**July 2000**

# **MAINTENANCE BULLETIN**

**Alfa Company**

## **New Steel Thrust Plate Replaces Bronze Thrust Plate in Hydraulically Actuated Electronically Controlled Unit Injector (HEUI) Pump Drive Groups**

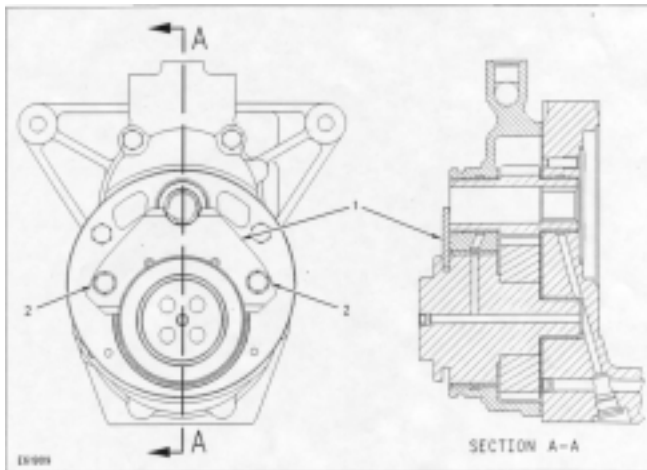
**Description Of Change:** A new steel thrust plate is used in the Hydraulically Actuated Electronically Controlled Unit Injector (HEUI) pump drive groups on the 3408E (99C) and 3412 (80M) Engines in these machines. The new steel thrust plate provides greater strength to resist breakage in high load applications. A broken thrust plate can result in the loss of the speed-timing signal.

**Adaptable To:** The new 150-2392 Thrust Plate (1) and 9N-0869 Washers (2) replace the former 124-6639 Thrust Plate and 9M-1974 Washers in the 125-3427 and 125-3430 HEUI Pump Drive Groups on 3408E (99C) and 3412E (80M) Engines respectively. The former 124-6639 Thrust Plate is canceled.

Location of the new 150-2392 Thrust Plate and 9N-0869 Washers in the HEUI Pump Drive Groups.

### Illustration 1

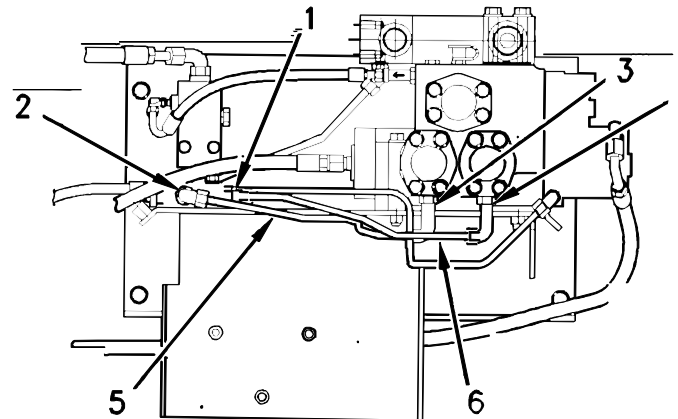
**Description Of Change:** Improved hoses are now used on the 988F Series II Wheel Loader steering control. The new hoses provide a longer service life and better serviceability. The new hoses are effective with 988F Series II (PIN: 2ZR2014-Up) Wheel Loaders.

3. Remove 8T-1 905 Elbow (3). Replace 8T-1905 Elbow (4) with a 3J-1907 Seal and a 7W-7381 Outlet Fitting. Attach a 6V-8724 Elbow with a 6V-8397 O-ring Seal and a 3J-1907 O-ring Seal to the 7W-7381 Outlet Fitting.

4. Install 6V-8636 Seal Adapter (7) with a 3J - 1907 O-ring Seal and a 6V-8397 O-ring Seal. Install 178-7981 Hose Assembly (8). Install 178-7981 Hose Assembly (9).
